Service Bulletin

Fuselage - Primary Structure, Center-Mid Fuselage - Routing Modification of the VFG Power-Feeder Harnesses

BD500-534101
Issue No. 008

Fuselage - Primary Structure, Center-Mid Fuselage - Routing Modification of the VFG Power-Feeder Harnesses - Service Bulletin

Figure 1 Inspection of the VFG Power-Feeder Harnesses and Wheel Bins

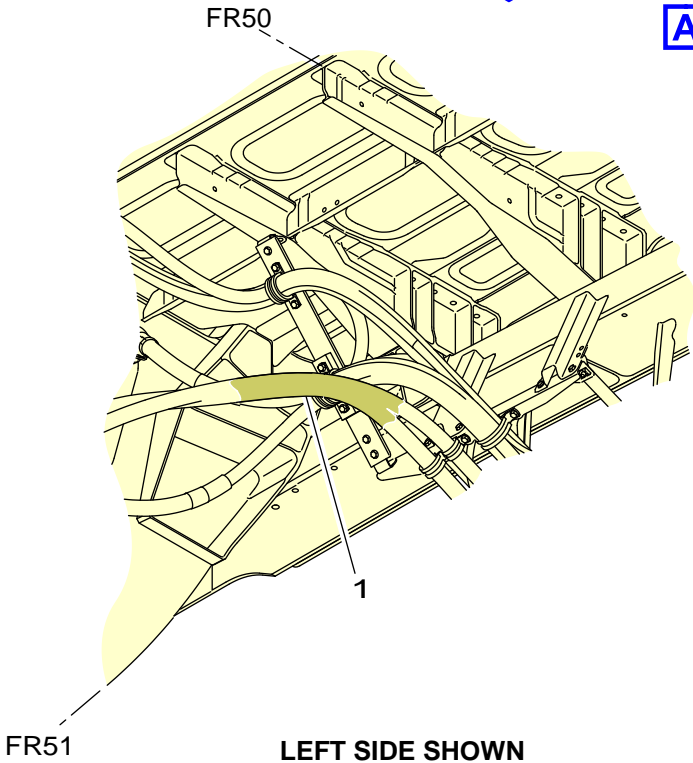
- 2.1 If it is not possible to complete all the instructions in this service bulletin because of the configuration of the aircraft, speak with a CRC representative at 1-866-A220-CRC (1-866-222-0272) or 1-450-476-7676 or e-mail at A220_crc@abc.airbus for analysis and to get an approved disposition to complete this service bulletin.
- 2.2 Remove the left wheel bin (refer to AMP BD500-A-J53-82-84-07AAA-520A-A).
- 2.3 Remove the right wheel bin (refer to AMP BD500-A-J53-82-84-08AAA-520A-A).
- 2.4 Do a visual inspection for damage at the intersection of the Variable Frequency Generator (VFG) power-feeder harnesses and the surface of the wheel bins, left and right sides as follows:

- 2.4.1 If you find damage on the VFG power-feeder harnesses and/or the wheel bins on the left and/or right side, speak with a Customer Response Center (CRC) representative at 1-866-A220-CRC (1-866-222-0272) or 1-450-476-7676 or e-mail at A220_crc@abc.airbus.
- 2.4.2 If no damage is found on the VFG power-feeder harnesses and/or the wheel bins, do PART B or PART C of the service bulletin.
- 2.4.3 If necessary, install the left wheel bin (refer to AMP BD500-A-J53-82-84-07AAA-720A-A).
- 2.4.4 If necessary, install the right wheel bin (refer to AMP BD500-A-J53-82-84-08AAA-720A-A).

Figure 1 Modification of the VFG Power Feeder-Harnesses Routing

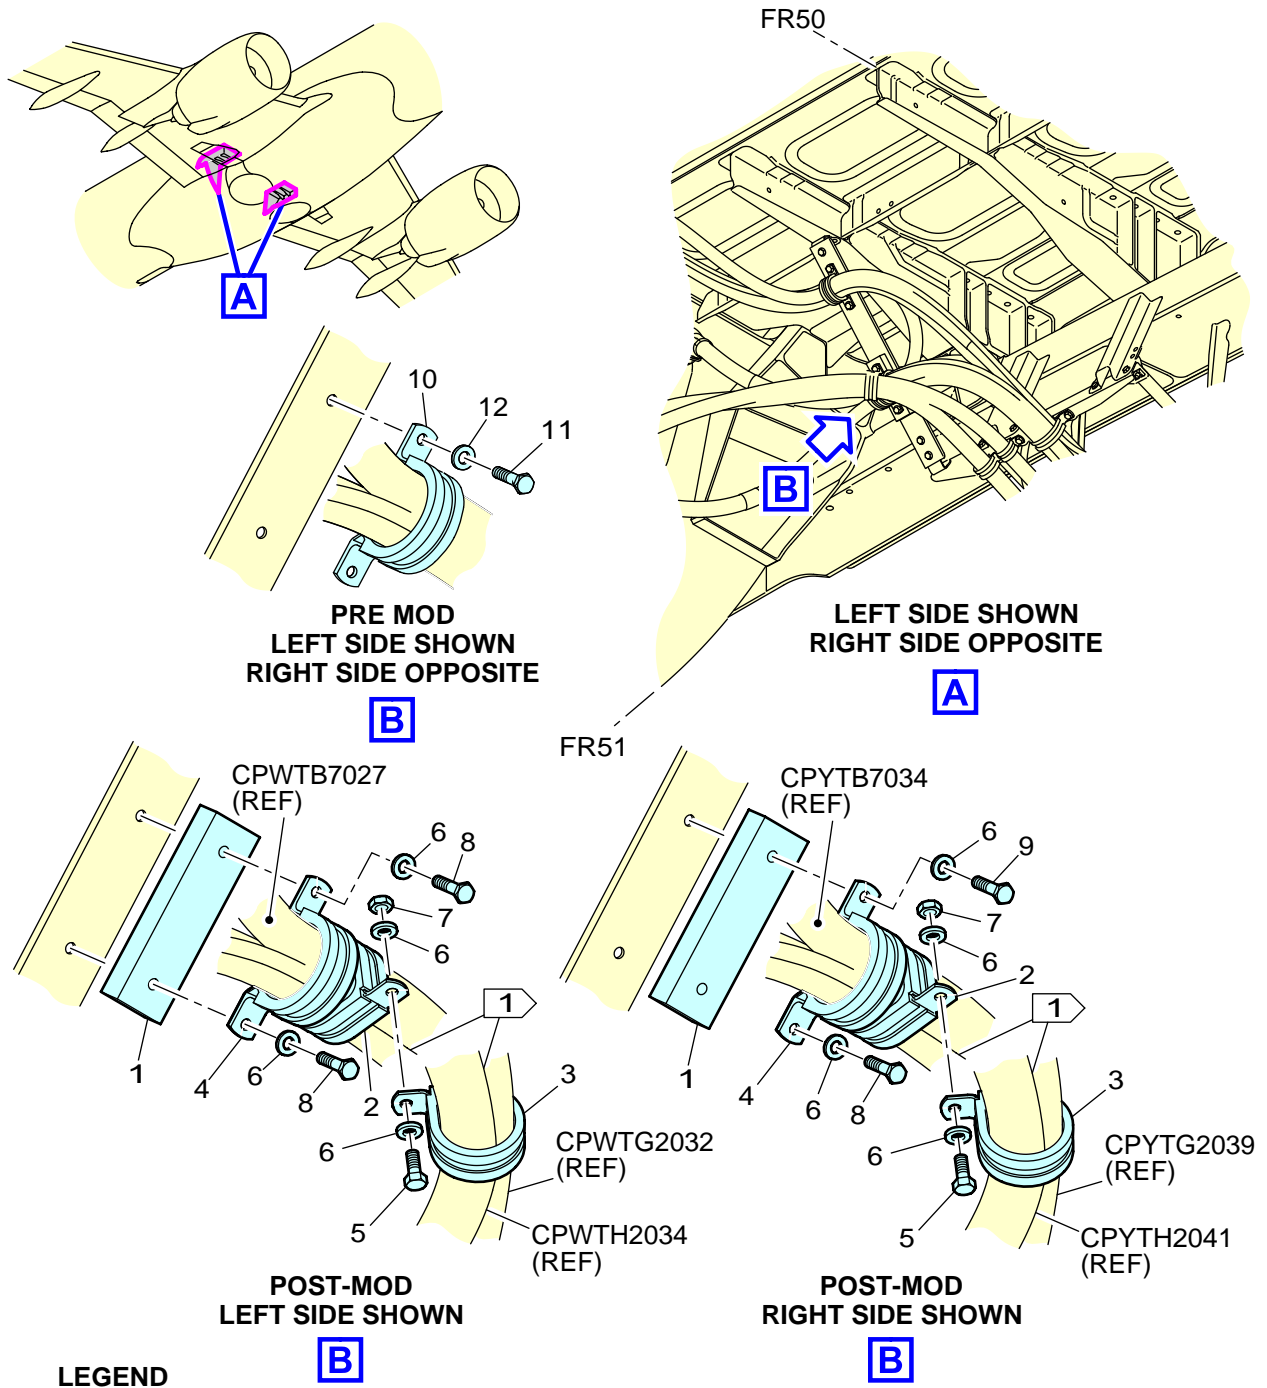
- 3.4 Modify the harness installation on the left side as follows:
Refer to Fig. 1
 - 3.4.1 Remove and discard the saddle clamp (10), screws (11) and washers (12) from the harnesses.

- 3.4.2 Install the harnesses with a packer (1), and saddle clamp (4), screws (8), and washers (6) (refer to AMP BD500-A-J20-10-01-00AAA-720A-A and ASRP BD500-A-J51-41-02-00AAA-078A-A).

- 3.4.3 Torque the screws (8) to 25.0 to 35.0 lbf•in (2.83 to 3.95 Nm) (refer to AMP BD500-A-J20-31-00-00AAA-711A-A).

Be careful not to cause damage to the harness. The bend radius of the harness CPWTH2034 must not be less than 12 times its outside diameter.

- 3.4.4 Install a clamp (2) forward or aft of the clamp (4) around the harnesses and a clamp (3) around the Variable Frequency Generator (VFG) power-feeder harnesses CPWTG2032 and CPWTH2034. Attach the two clamps (2) and (3) with screw (5), washers (6), and one self-locking nut (7) (refer to AMP BD500-A-J20-10-01-00AAA-720A-A and ASRP BD500-A-J51-41-02-00AAA-078A-A).

- 3.5.1 Remove and discard the saddle clamp (10), screws (11), and washers (12) from the harnesses.
 - 3.5.2 Install the harnesses with the packer (1), saddle clamp (4), screw (8), screw (9), and washers (6) (refer to AMP BD500-A-J20-10-01-00AAA-720A-A and ASRP BD500-A-J51-41-02-00AAA-078A-A).

Figure 1 Left side - Routing modification of the power-feeder harnesses - Removal - (Sheet 1 of 2)

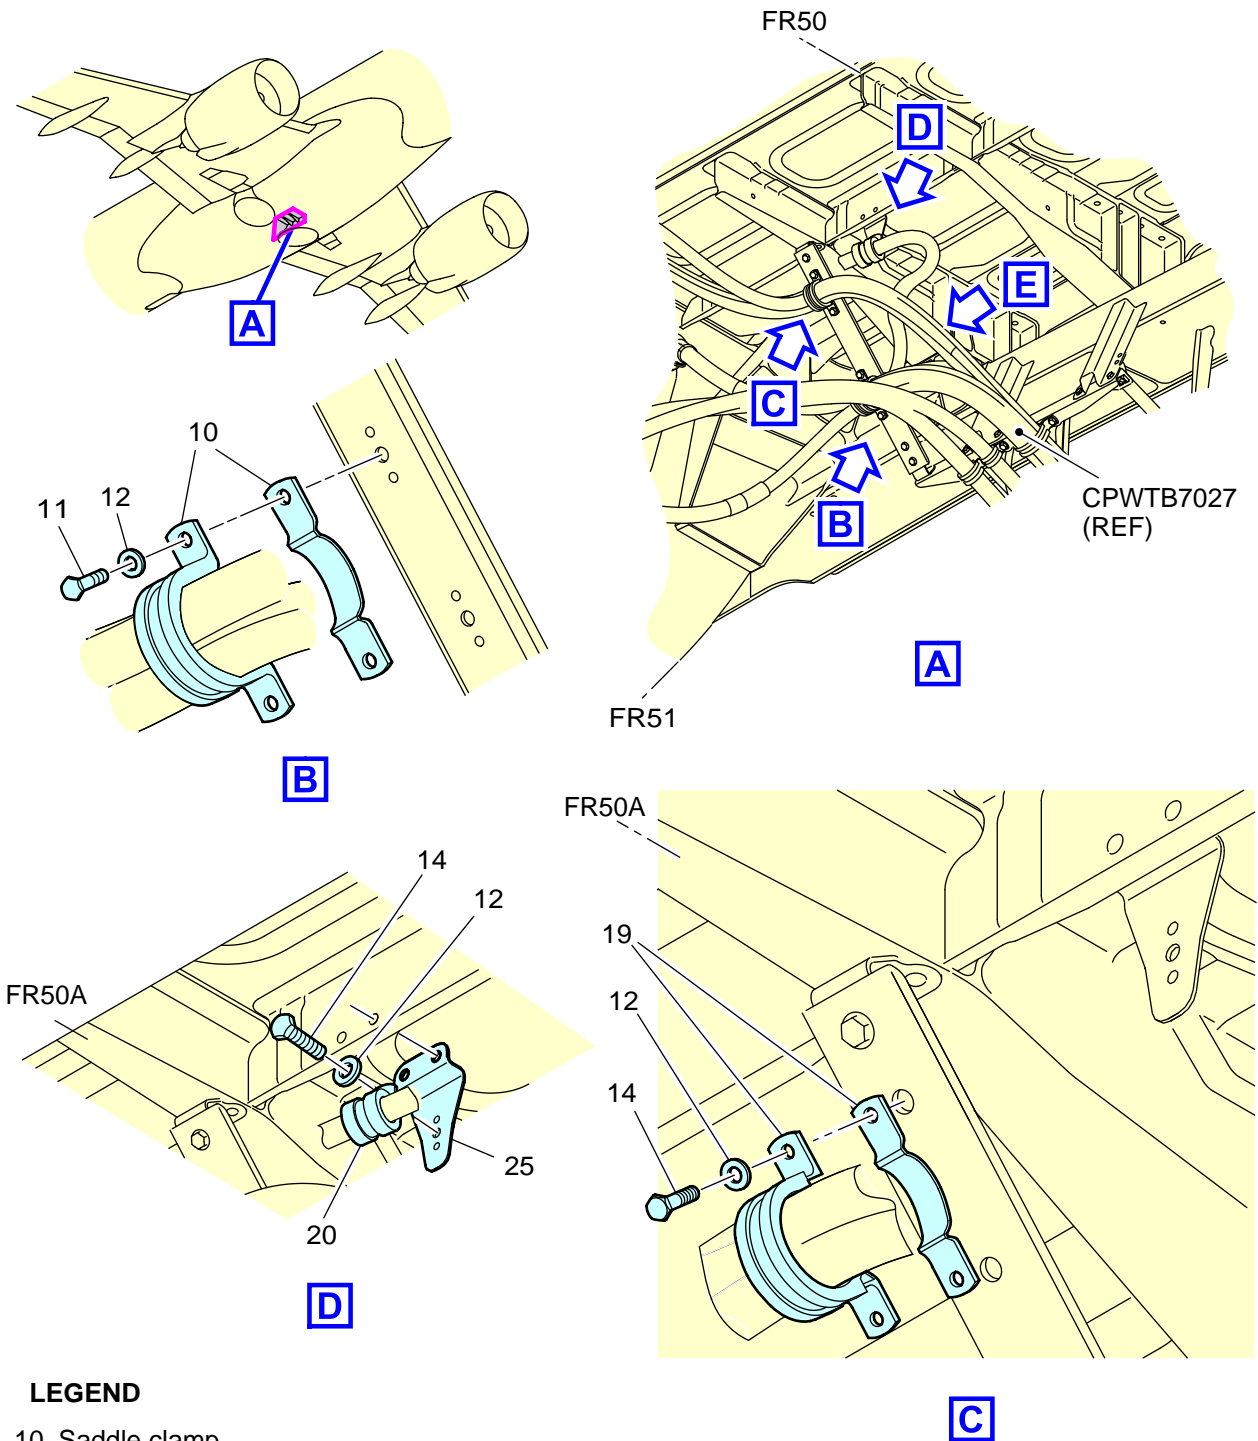
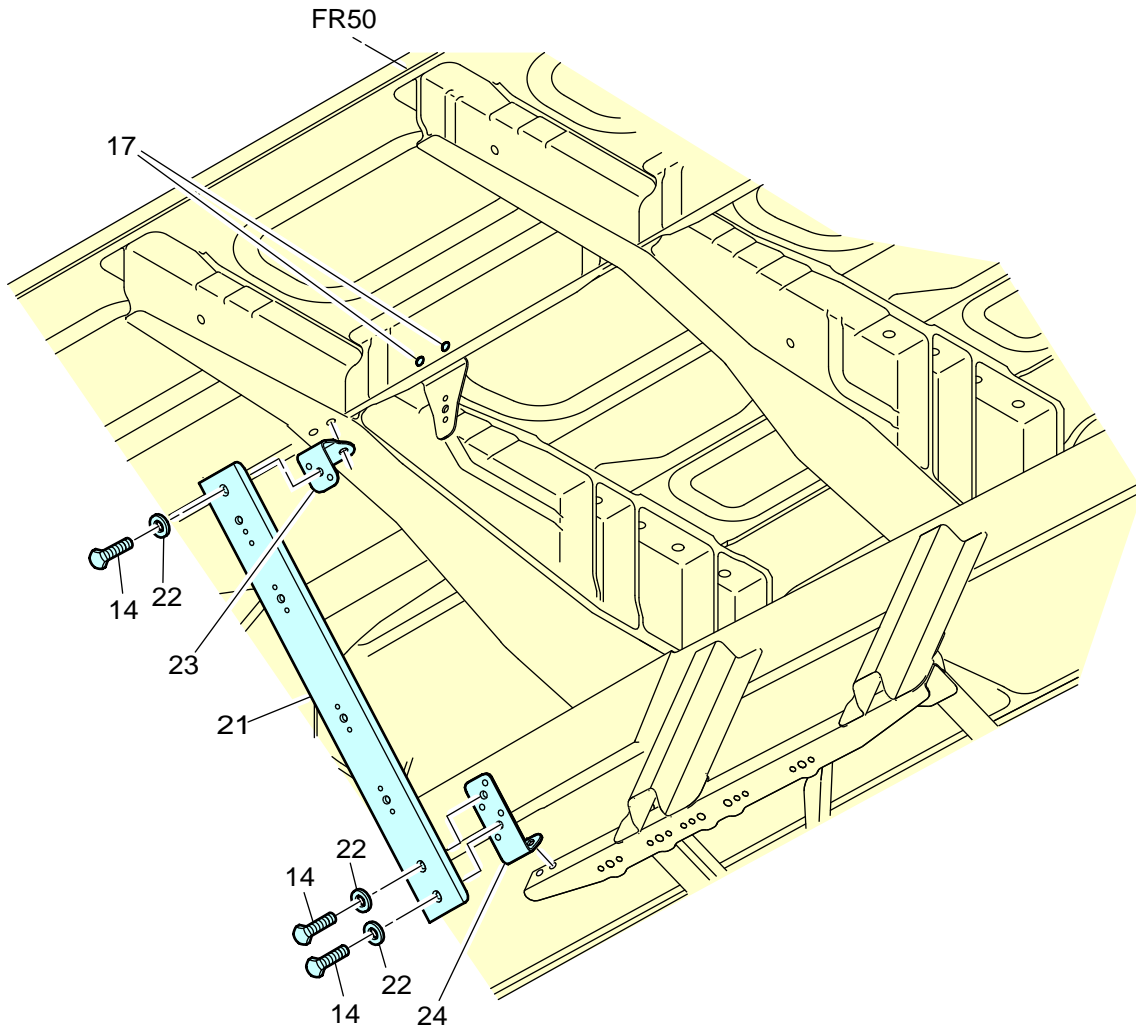
- 3.2.1 Remove the saddle clamp (10), screws (11), and washers (12) that hold the harness CPWTB7027.
- 3.2.2 Discard the screws (11). Keep the saddle clamp (10) and the washers (12).

- 3.2.3 Remove and keep the saddle clamp (19), two screws (14), and two washers (12) that hold the harness CPWTB7027.
- 3.2.4 Remove the loop clamp (20), screw (14), and washer (12).

- 3.2.5 Discard the loop clamp (20). Keep the screw (14) and the washer (12).
- 3.2.6 Remove the electrical system support assembly (21), screws (14), and washers (22).

- 3.2.7 Discard the electrical system support assembly (21). Keep the screws (14) and the washers (22).
- 3.2.8 Remove and discard the two electrical system bracket assemblies (23) and (24) (refer to ASRP BD500-A-J51-42-06-00AAA-078A-A).

- 3.2.9 Remove the electrical system bracket assembly (25) (refer to ASRP BD500-A-J51-42-06-00AAA-078A-A).
- 3.2.10 Wet-install with sealant two rivets (17) in the redundant holes in the intercostal where the electrical system bracket assembly (25) was installed (refer to ASRP BD500-A-J51-42-06-00AAA-078A-A and ASRP BD500-A-J51-23-00-05AAA-259B-A).

Figure 2 Left side - Routing modification of the power-feeder harnesses - Removal - (Sheet 1 of 2)

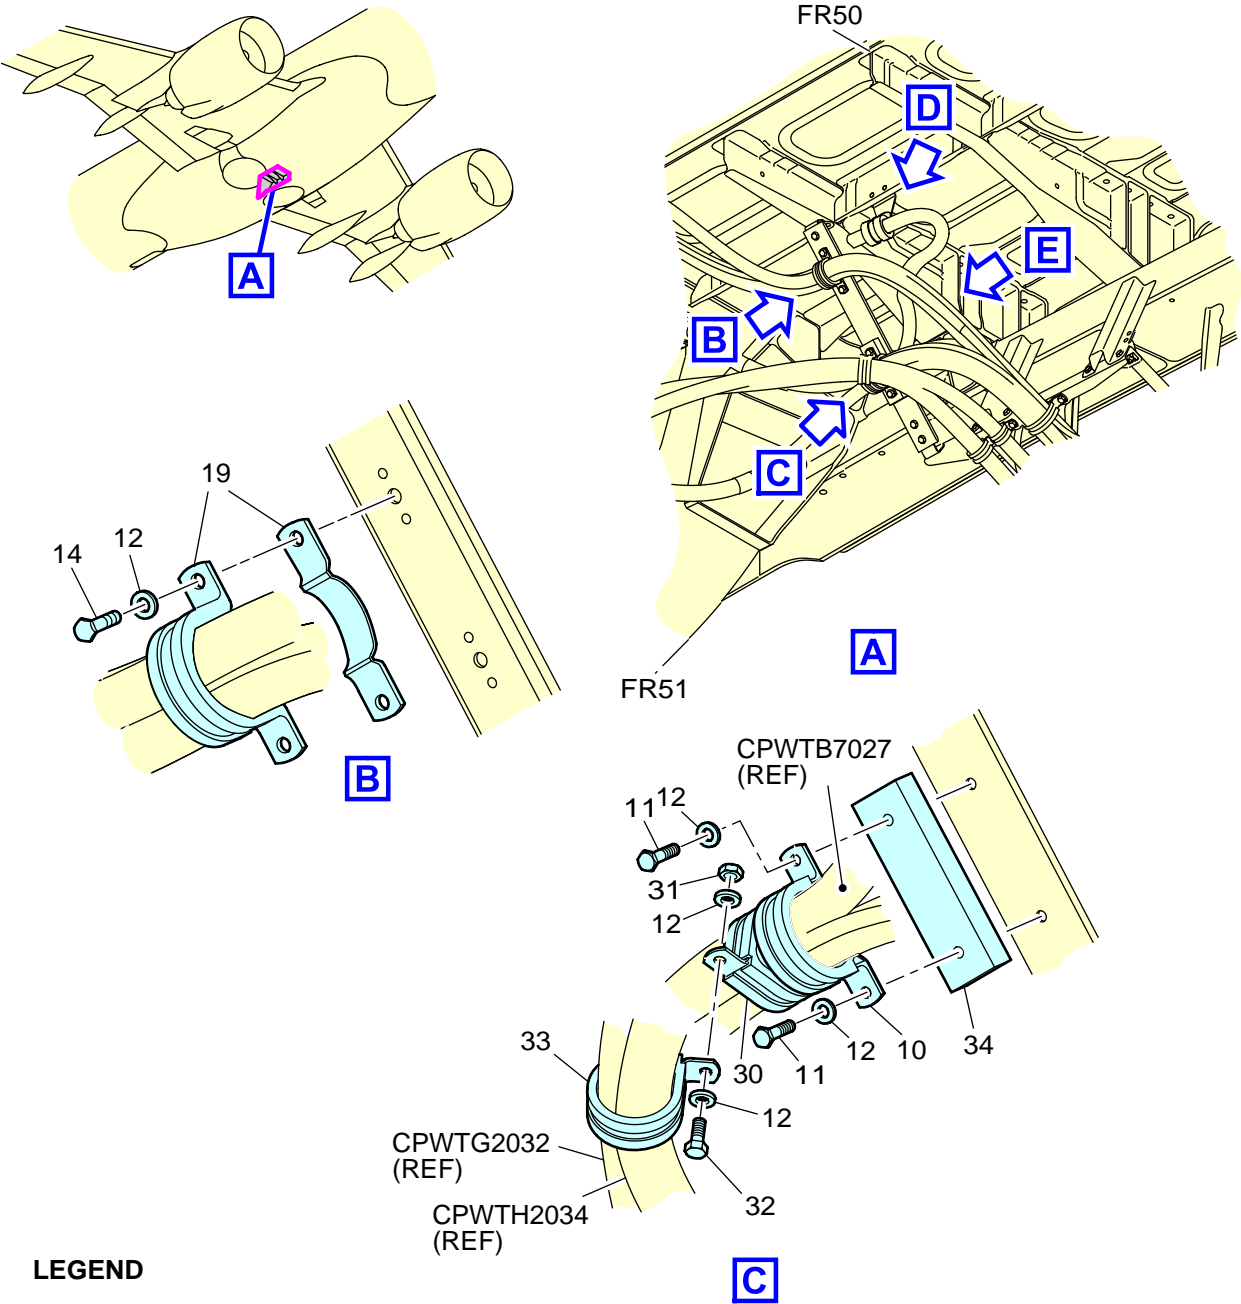
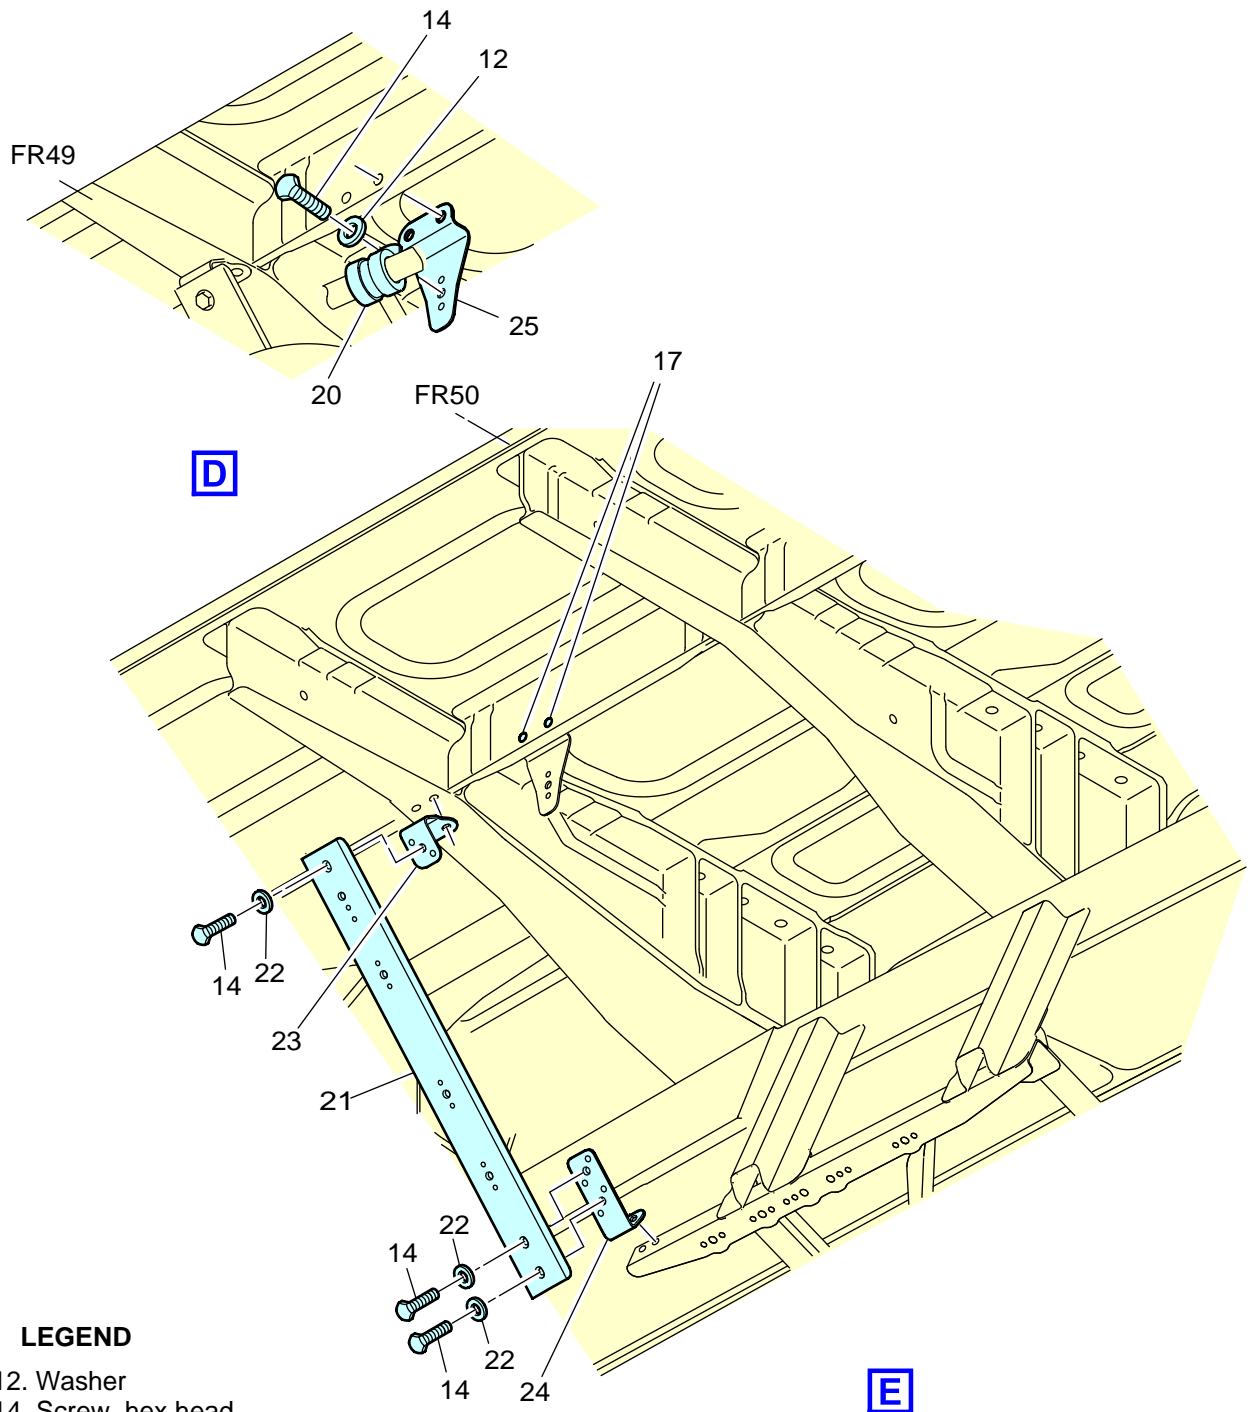
- 3.3.1 Remove the clamp (30), clamp (33), nut (31), screw (32), and washers (12) that hold the harnesses CPWTH2034 and CPWTG2032.
- 3.3.2 Discard the clamp (30), clamp (33), nut (31), and screw (32). Keep the washers (12).

- 3.3.3 Remove the saddle clamp (10), screws (11), packer (34), and washers (12) that hold the harness CPWTB7027.
- 3.3.4 Discard the screws (11) and packer (34). Keep the clamp (10) and the washers (12).

- 3.3.5 Remove and keep the saddle clamp (19), two screws (14), and two washers (12) that hold the harness CPWTB7027.
- 3.3.6 Remove the clamp (20), screw (14), and washer (12).

- 3.3.7 Discard the clamp (20). Keep the screw (14) and the washer (12).
- 3.3.8 Remove the electrical system support (21), screws (14), and the washers (22).

- 3.3.9 Discard the electrical system support assembly (21). Keep the screws (14) and the washers (22).
- 3.3.10 Remove and discard the two electrical system bracket assemblies (23) and (24) (refer to ASRP BD500-A-J51-42-06-00AAA-078A-A).

- 3.3.11 Remove the electrical system bracket assembly (25) (refer to ASRP BD500-A-J51-42-06-00AAA-078A-A).
- 3.3.12 Wet-install with sealant two rivets (17) in the redundant holes of the electrical system bracket (25) on the intercostal (refer to ASRP BD500-A-J51-42-06-00AAA-078A-A and ASRP BD500-A-J51-23-00-05AAA-259B-A).
